Downwinders
Cleaner Air Through Citizen Action *at risk*

February 11, 2015

**Re: Commission Approval for Proposed Dallas-Fort Worth (DFW) 2008 Eight-Hour
Ozone Nonattainment Area Attainment Demonstration (AD) State
Implementation Plan (SIP) Revision, SIP Project No. 2013-015-SIP-NR**

Figure 1 : Final Report, Accounting for the Impacts of Variable Cement Kiln Emission Rates on Ozone Formation in the Dallas/Fort-Worth Area, Work Order No. 582-04-65563-08, Prepared for Texas Commission on Environmental Quality, ENVIRON International August 31, 2005).

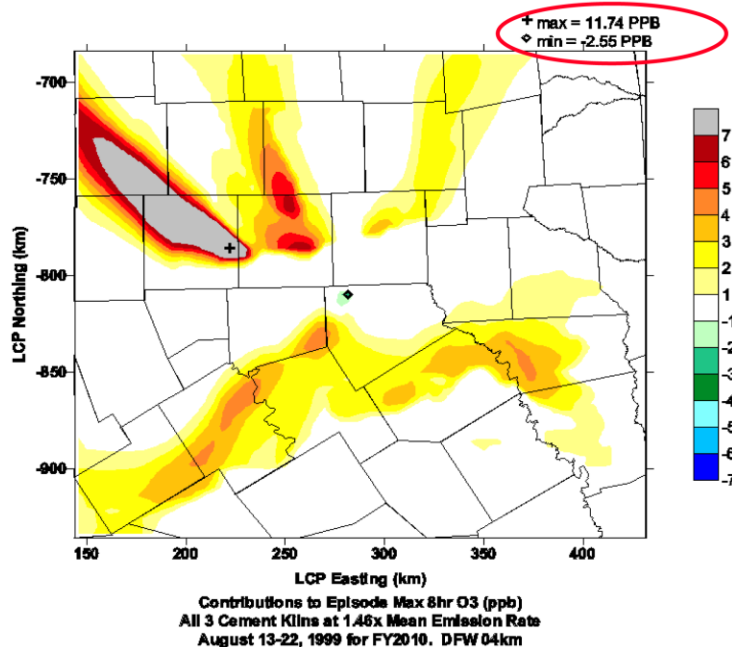
Studies have demonstrated that Midlothian cement plant pollution significantly affects DFW ozone levels. In fact, in 2005 and 2006, two sets of TCEQ’s own “sensitivity tests” performed to quantify the impact of the Midlothian cement plants on air quality in the DFW non-attainment area as part of a new 2007 State Implementation Plan for Ozone. This new plan DFW SIP was necessitated, in large part, by TCEQ’s underestimation of the number of diesel generators connected to Barnett Shale gas drilling in DFW, and EPA’s rejection of the TCEQ plan that was initially approved. EPA’s rejection was based on four monitors in Tarrant and Dallas Counties registering ozone levels over 85 ppb in modeling runs performed by the state and EPA. Thus, a “do-over” implementation plan to reach attainment with the 85 ppb standard was necessary to obtain federal approval. Both sets of cement plant sensitivity tests were carried out by Environ, on behalf of the Texas Commission on Environmental Quality.

The August 2005 Environ sensitivity tests identified the worst-case scenarios for maximum impact of the plumes of all three cement plants to air quality in the DFW non-attainment area. It used projected 2010 future year emissions for an episode from August 13-22, 1999. It demonstrated a maximum impact of over 11 ppb along the Parker-Tarrant County line, with impact of 1 to 11 ppb extending over 28 North and Central Texas counties:

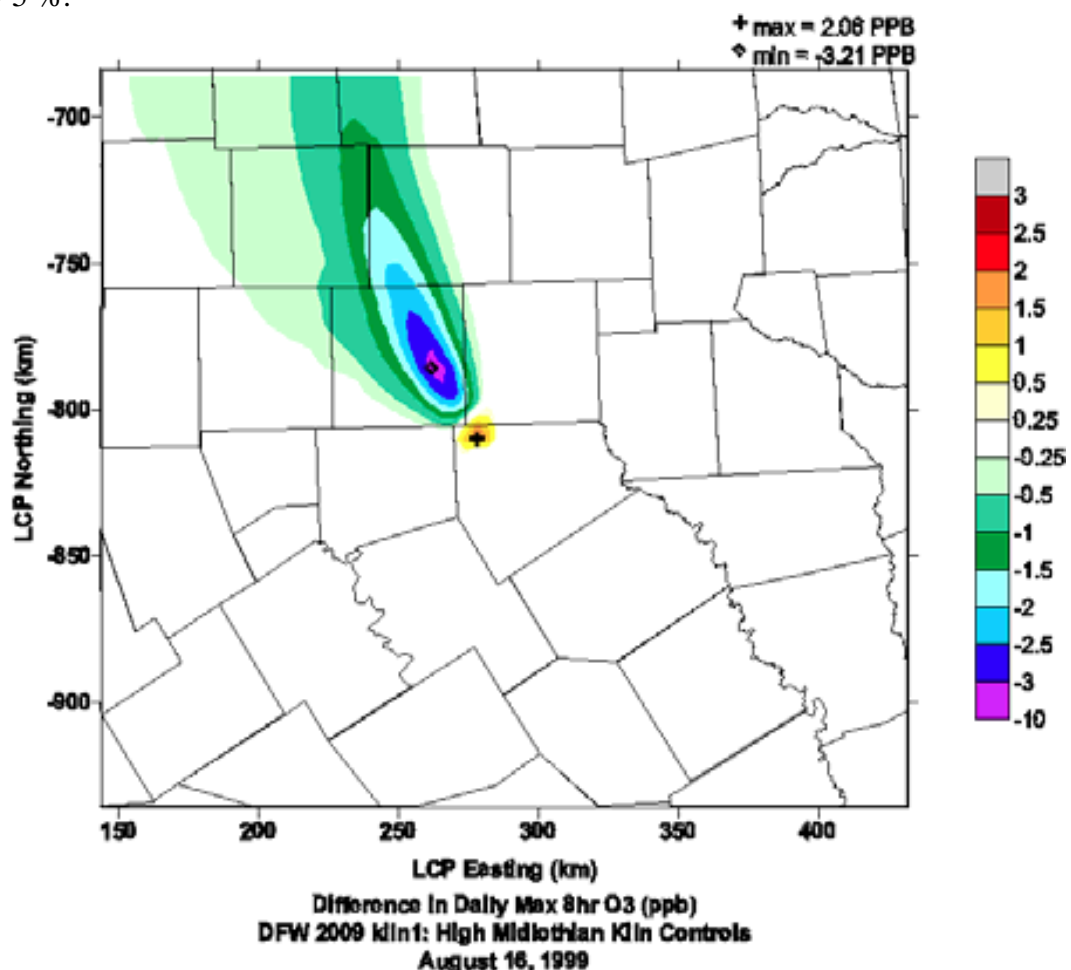
Sensitivity runs by Environ in 2006 demonstrated how reductions in kiln emissions from implementation of “low,” or Selective Non-Catalytic Reduction (SNCR) controls, and “high,” or Selective Catalytic Reduction (SCR) controls would impact air quality in the DFW non-attainment area:

2009 8-hour ozone design value was reduced nearly 1.0 ppb when applying the “high level,” or SCR, controls. The high cement kiln control reduced the future design value at least 0.1 ppb at 5 of the 9 monitoring sites.⁷⁷ Among the 2009 baseline “exceedance” cells, (i.e. cells exceeding the 85 ppb standard in the modeling episode), 14 % (166 out of 1199) were reduced at least 1 ppb. The controls were most effective on August 16, when 38 % (84 out of 223) exceedance grid cells were reduced at least 1 ppb, accounting for half the episode total; the exceedance area was lower by 5 %.⁷⁸

Figure 2: Change in Weekday NOx Emissions from East Texas EGUs with SCR

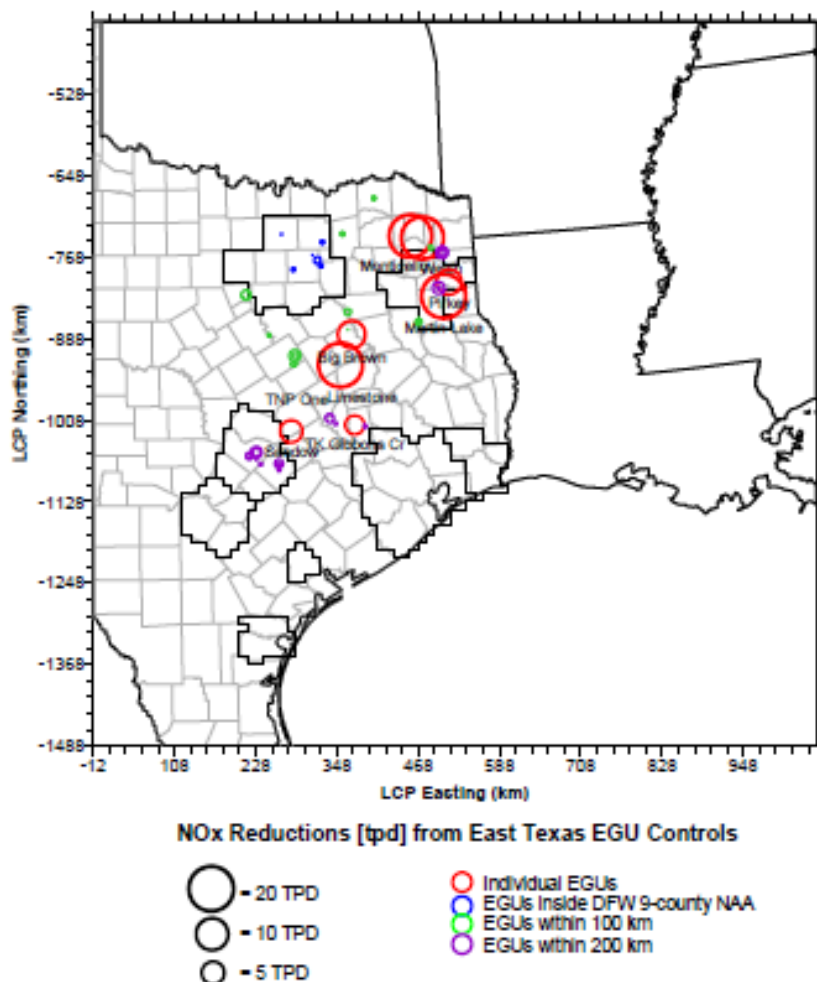
As the modeling makes clear, the application of SCR at the coal-fired EGUs in central and eastern Texas would result in considerable reductions of ozone in the DFW area. DFW monitors in the south (Midlothian and Arlington) showed the greatest reduction in the 2009 8-hour ozone design values, dropping 1.5 and 1.0 ppb, respectively. The future design values at all other monitors were reduced 0.5 to 0.8 ppb from the 2009 baseline, including Frisco, down 0.8 ppb to 90.5 ppb. The East Texas EGU controls reduced the ozone episode exceedance area by 6 %, as 17 % of the exceedance cells were reduced at least 1 ppb. As demonstrated below, the modeling indicated that on dates with an east wind (e.g., the August 15), the DFW 9-county NAA was surrounded by a plume of ozone reduction in northern DFW with origins near the Monticello and Welsh EGUs, and a plume in southern DFW with origins near the Pirkey and Martin Lake EGUs.

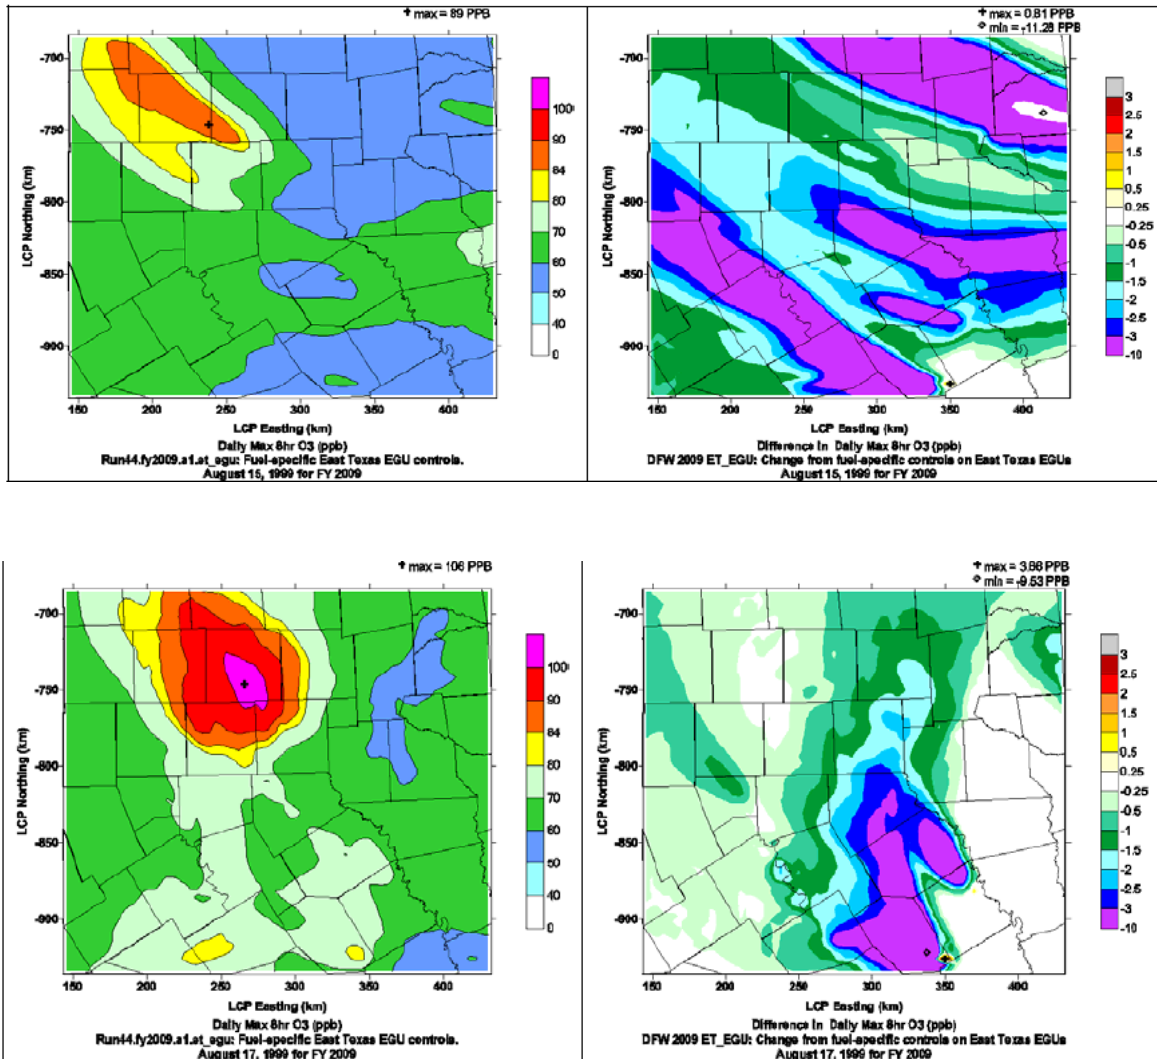
On dates with a south wind (particularly August 17), ozone reduction was strongest in southern DFW, mainly due to the NOx controls at the Big Brown and Limestone EGUs. *See below.*

The Environ modeling demonstrates that the installation of modern NO_x controls at the eastern Texas coal-fired EGUs. Indeed, SCR at DFW-area coal-fired EGUs and cement kilns is capable of reducing the future design values in the DFW nonattainment area by as much as 2 ppb. Given that TCEQ admits that several of its DFW monitors will be as much as .5 ppb above the NAAQS in 2018, the implementation of SCR as RACM would have demonstrable benefits for DFW ozone levels, and would ensure timely attainment of the 2008 eight-hour standard.

Figure 3: Location of the 647 large compressor stations in the DFW non-attainment area.
Source: TCEQ 2014

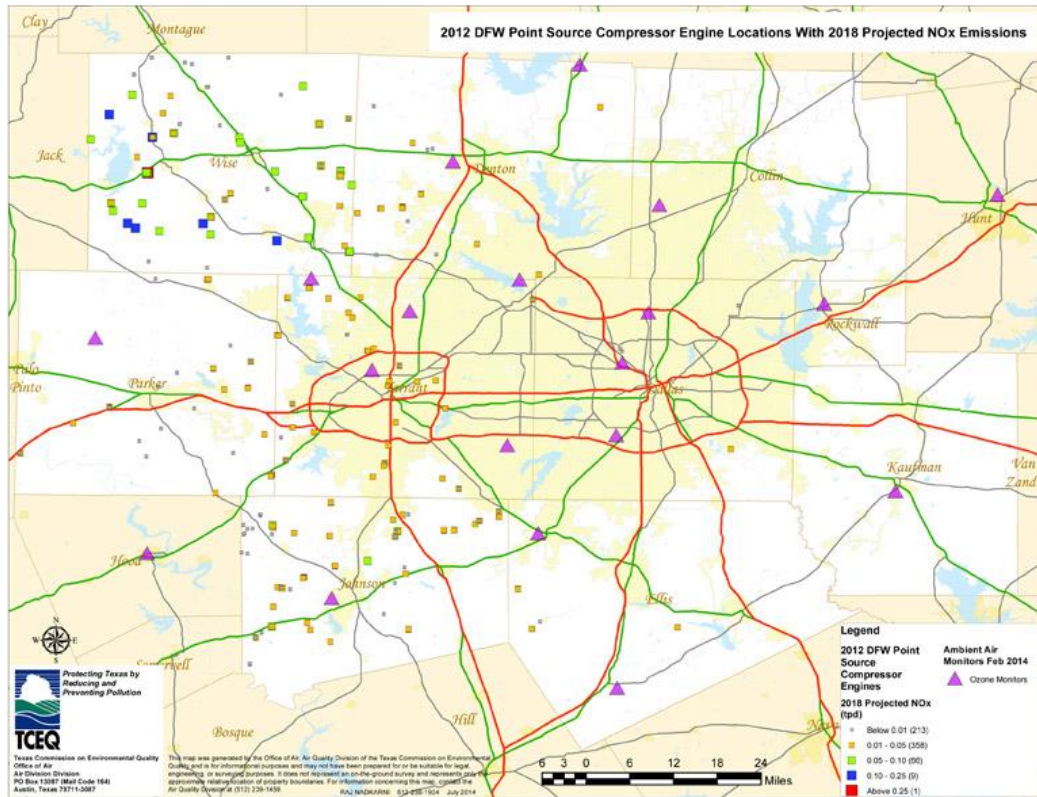
the worst-performing air quality monitors, including the one driving the DFW design value (Denton airport in Denton County), and the two other sites that are also on the cusp of violating, or actually do violate the 75 ppb standard by the 2018 deadline (Eagle Mountain Lake and Grapevine Fairway in Tarrant County).

Unlike the Midlothian cement plant or East Texas coal plants, TCEQ has never performed “sensitivity tests” in its modeling episodes demonstrating how cuts in compressor emissions could influence ozone levels at specific DFW non-attainment area monitors. Yet, TCEQ has recognized the influence is significant.¹⁴⁴ When TCEQ plugged-in lower 2018 emission rates for oil and gas facilities, the Denton air quality monitor had almost an entire 1 ppb reduction in its projected 2018 design value. TCEQ admitted that this reduction was due in whole to the reduction in oil and gas emission inventory. This makes sense because compressors comprise more than 60% of all oil and gas NO_x emissions, and more than 50% of the industry’s total VOC releases. Since TCEQ is also linking compressor emissions to overall production rates, when lower production rates were plugged into the episode, those rates resulted in lower compressor emissions in the model episode. Indeed, over half of the large decrease in Denton’s design value is logically attributable to lower compressor emissions.
